NEWMAR CORPORATION WARRANTY DEPARTMENT

RECALL SERVICE BULLETIN

DATE ISSUED	MODEL YEAR(S) AFFECTED	RSB #
12/15/2016	2017	473

How to Replace the Accent Light Module

Inspecting the New Module

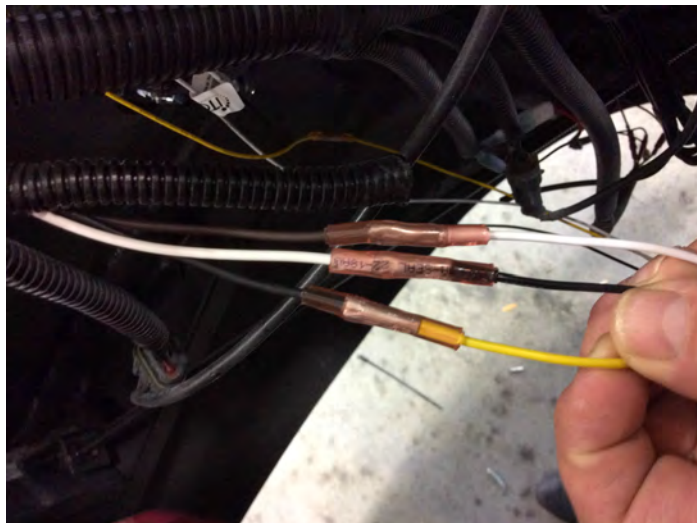
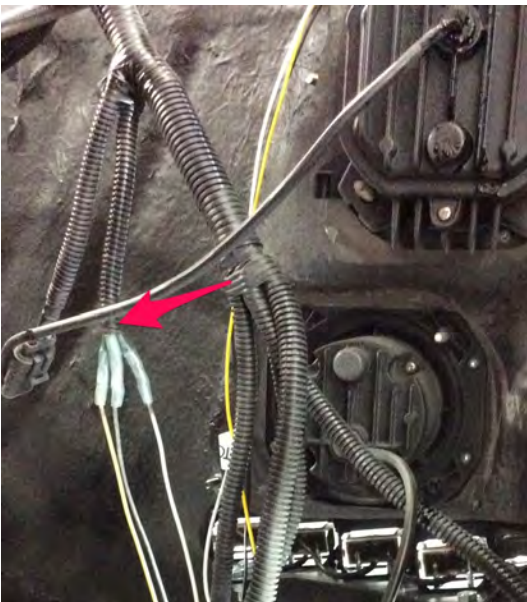
The new sealed light module will have stripped wire leads on one side, which will connect to the coach wiring. The other side will have connectors on them. It is important to correctly install the module due to a diode that was added.

1. Locate the three wires connecting the accent light to the light module.
2. Cut the connection from the light module, and strip the three wires back.
3. On the new module, find the side with terminals. This will hook up to the light, so do not reverse them.

4. Cut off the terminals, and strip back the wires.
5. Using red butt connectors, attach the three wires (color to color) on the light side.
6. Use a mini torch or lighter to heat and seal the butt connectors.

7. From the harness side of the module, cut off the old connectors.
8. Pull back the black wire loom if necessary.
9. Strip back the wires.
10. Hook up the wires as shown.

- Harness black = Module yellow
 - Harness white = Module black
 - Harness brown = Module white
11. Heat and seal the butt connectors.
